Environmental Review Team Report

Breslin Subdivision

Old Lyme, Connecticut

August 1978

PRELIMINARY SUBDIVISION PLAN

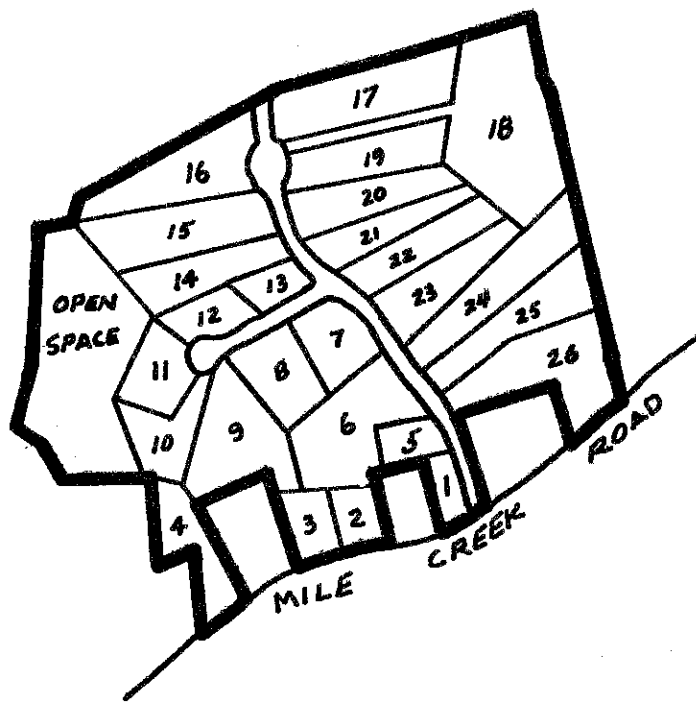
Shallow to bedrock soils occur within the area, particularly along the western portion of the parcel. Roads, basements, and driveways should be located to avoid shallow bedrock problems. Lots #8, 9, 10, 11, 12, 13, 14, and 18 require special attention in this regard.

The location of the 5.6± acres of open space along Armstrong Brook will provide a measure of preservation to this watercourse and wetlands; however, the site plan provides no access into this area other than from adjacent lots 10-15 and from a questionable 21' easement which seems to extend from Mile Creek Road up the center of the brook. This open space area would be more accessible if the final site plan showed an easement extending from the cul-de-sac serving lots 10-11 or an easement running to the open space between lots 14/15. It should be noted that the applicant's Surface Report to the Planning Commission (4/12/78) suggested the possible use of this open space area as a likely location for a firewell. The design of the open space as shown on the preliminary plan does not permit its use for potential firewell sources because of the lack of access previously mentioned and because the steep slope along the Armstrong Brook boundary would be a hazard to fire equipment attempting to reach this area. A possible firewell source which could be investigated exists at the juncture of Mile Creek Road and the 21' easement up the Armstrong Brook. This location has direct road access. In addition, the Team observed in the field that the streambelt along the west side of Armstrong Brook is incrementally being filled by an adjacent property owner. Correction of this filling, the construction of a sediment basin on the north side of Mile Creek Road and a general "clean-up" of this easement might make it useable for fire protection water sources as well as a link in an open space corridor along the Armstrong Brook.

Construction of 2,355 feet of public road with curbing and a conduit storm drainage system is proposed by the developer. There also is a 570± foot driveway accessing lot #18 from the northern cul-de-sac. A potential road extension to the Broath property to the north from this northern cul-de-sac is proposed. Installation of the roads, driveways, and houses will add 4± acres of impervious surfaces to the site. Final development plans should demonstrate adequate engineering design to prevent peak flow scouring and erosion at and below the outlets of the storm drain system. Peak discharges into natural areas or drainageways should be at a non-erosive velocity. Such practices as riprapping and energy dissipating plunge pools may be needed below the culverts under Mile Creek Road. The proposed riprap channel draining the northern cul-de-sac appears to be adequate. However, it is recommended that it outlet in a level lip spreader onto level ground where proposed.

A pocket of poorly drained soil, where water ponds temporarily, is located directly north of the northern cul-de-sac. Should the road be extended, a culvert will be needed and the roadbed should be designed to overcome potential frost heaving in these soils.

The developer may wish to adjust the finished grade of the main access road, as the proposed 10% finished grade will be steep under winter driving conditions.

It is also recommended that the access to the proposed open space right-of-way be relocated as it presently enters Mile Creek Road directly over Armstrong Brook. This route is severely limited for the development of a path or road if such were desired by the Town.

Wetlands and steep topography along the site's western perimeter (Armstrong Brook) should be left undisturbed. The proposed use of these areas for open space is compatible with the wetlands features. Wetlands along the subdivision's eastern boundary (lots 19-26) will require special care in the placement of sanitary facilities and residential uses.

-  Armstrong Brook watershed area.
-  Watershed affecting the culvert on Mile Creek Road at eastern edge of the property.

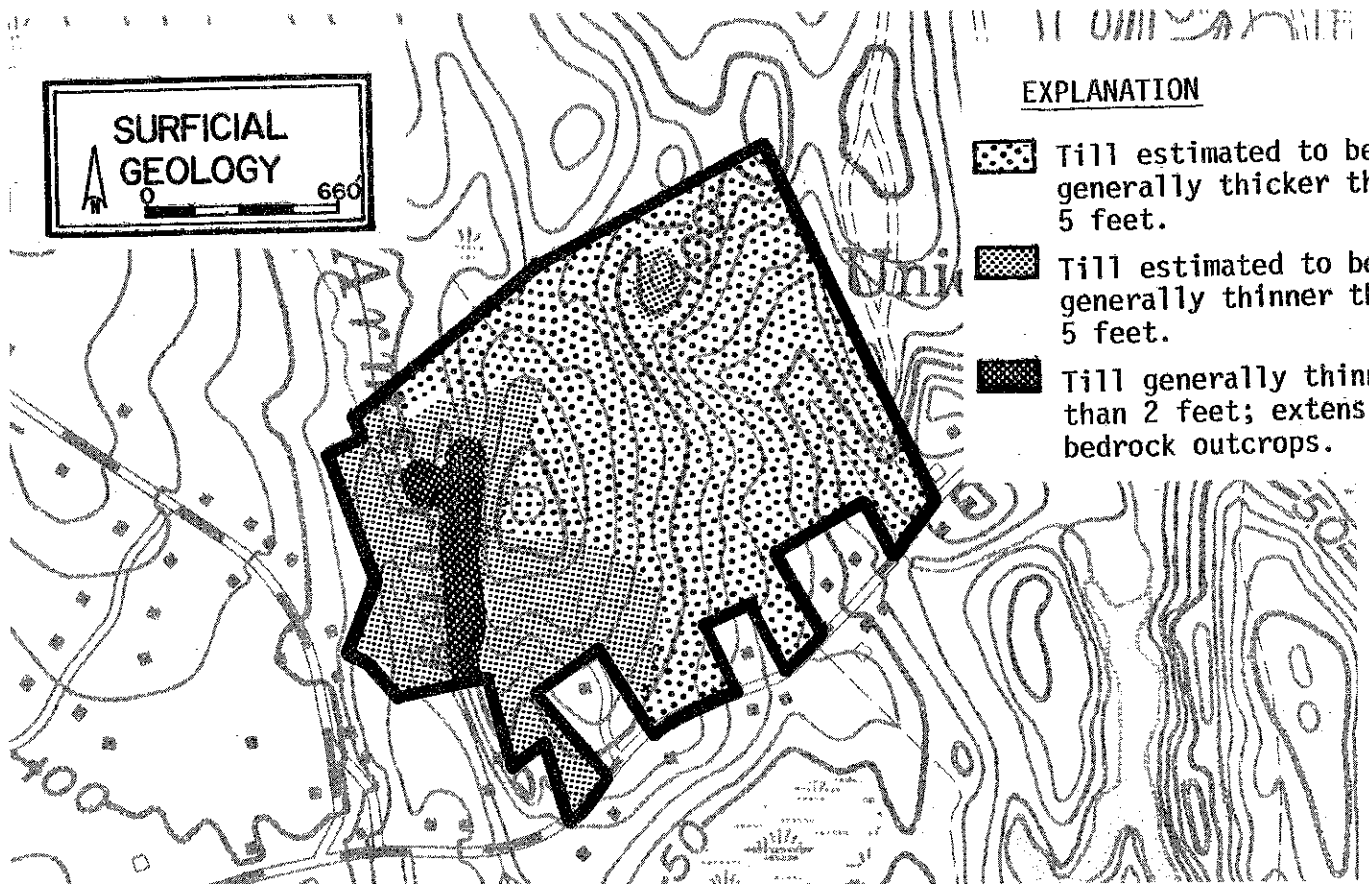
Peak flows at the culvert that receives water from the eastern part of the subdivision are likely to be increased significantly by the development. On the other hand, peak flows in Armstrong Brook at Mile Creek Road may not be noticeably affected. The reason for these different predictions is that Armstrong Brook receives additional runoff from an area that is many times larger than the contributing portion of the Breslin property; the watershed containing the eastern part of the property, however, includes very little additional land (see Watershed Map).
